**Section 75W Modification Requests
Bungarribee Industrial Estate, Huntingwood West Precinct
Concept Plan MP06_0203 MOD2
Stage 1 Infrastructure Works Project Approval MP08_0225 MOD1**

Director-General's
Environmental Assessment Report
Section 75W of the
Environmental Planning and Assessment Act 1979

February 2013

Figure 5: Stage 1 Infrastructure Works (MP08_0225) & Concept Plan modification (MP06_0203 MOD1)

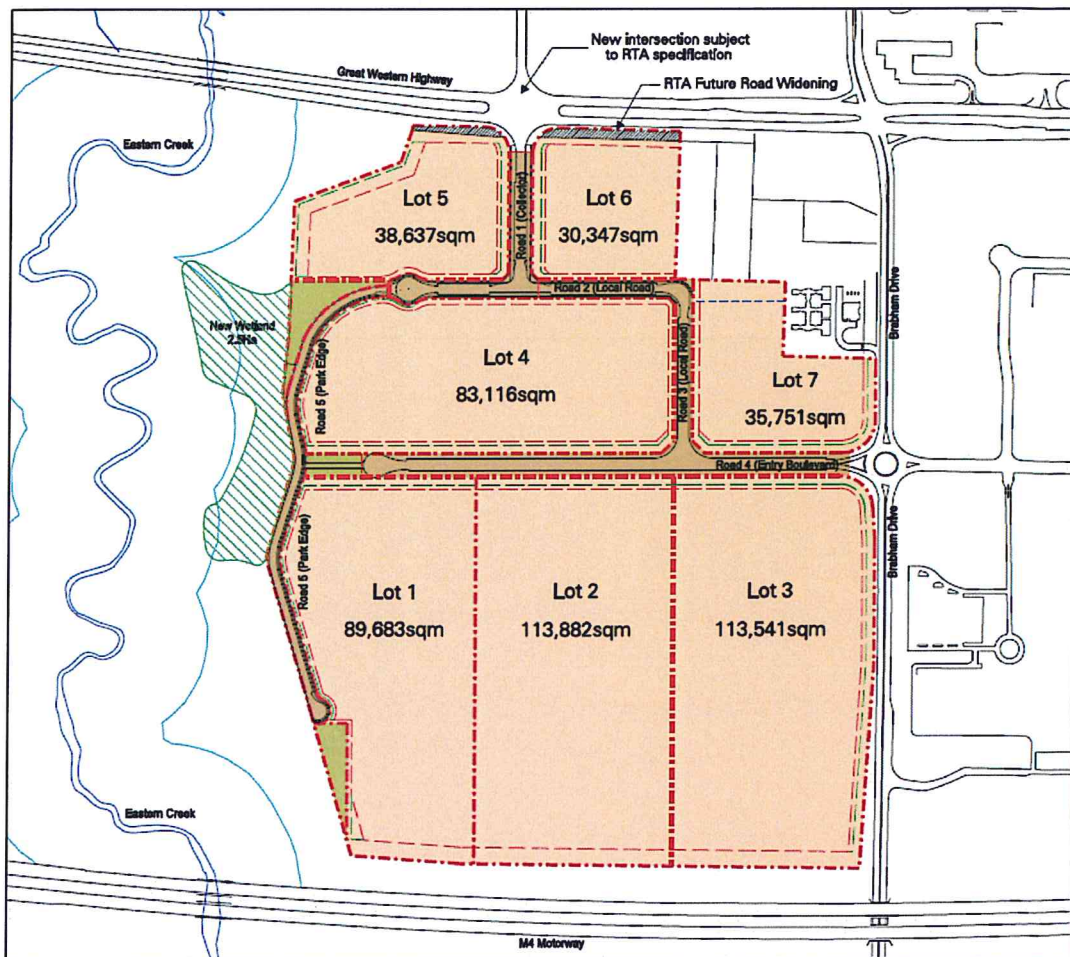
The site layout approved under concept plan MP06_0203 MOD1 (see **Figure 5**) resulted in 7 lots. This modification seeks a layout consisting of 6 lots as shown in **Figure 6**.

Figure 7: Proposed plan of subdivision

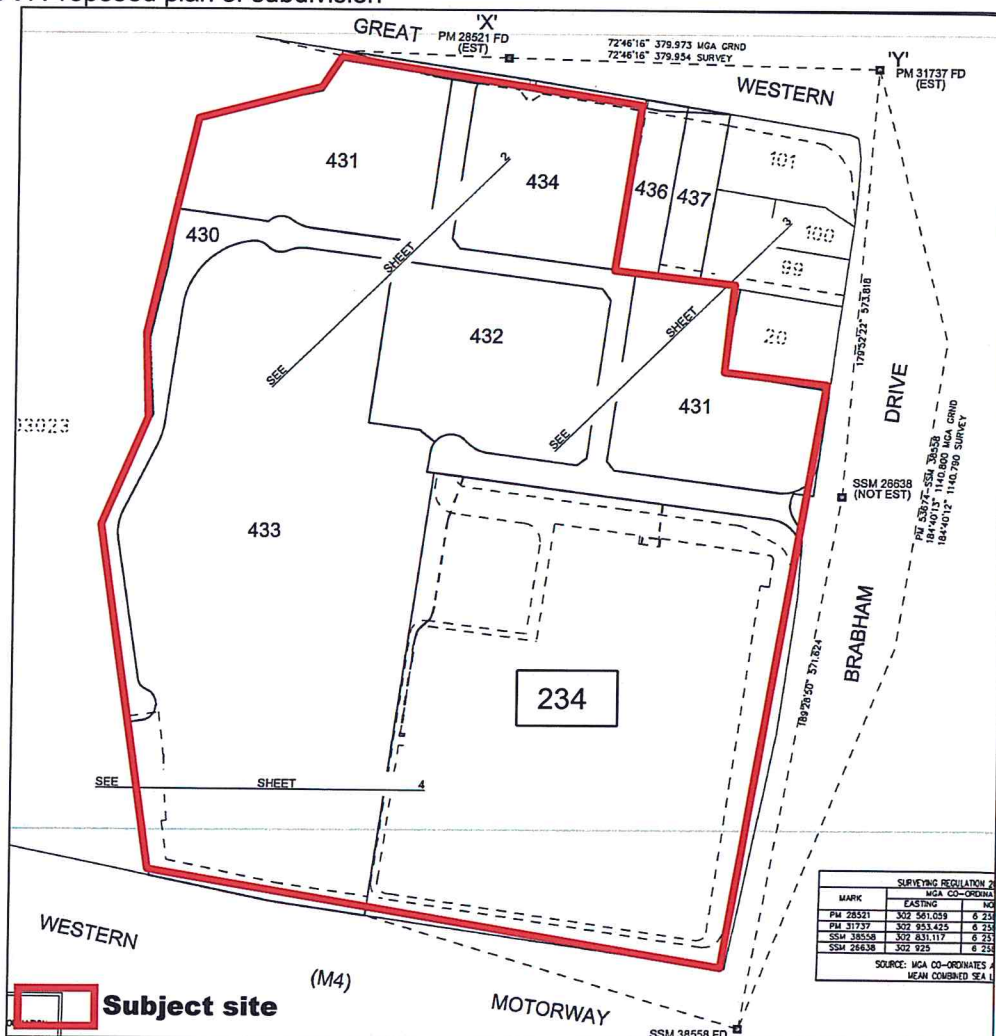
The proposed site layout shown in **Figure 6** is sought as is an amended plan of subdivision to be consistent with the site layout. The proposed plan of subdivision is shown in **Figure 7**.

The proponent is also seeking to amend the subdivision plan for the site. Subdivision has been approved under MP08_0055 and MP08_0225. The subdivision plan submitted as part of this modification request will be consistent with the revised site layout proposed and will require the proponent to surrender the subdivision approval under MP08_0055. A condition is proposed to the amended project approval to address this matter. The

proponent has agreed to this condition as the subdivision layout approved under MP08_0055 is now redundant. Subdivision approval will now be wholly under MP08_0225.
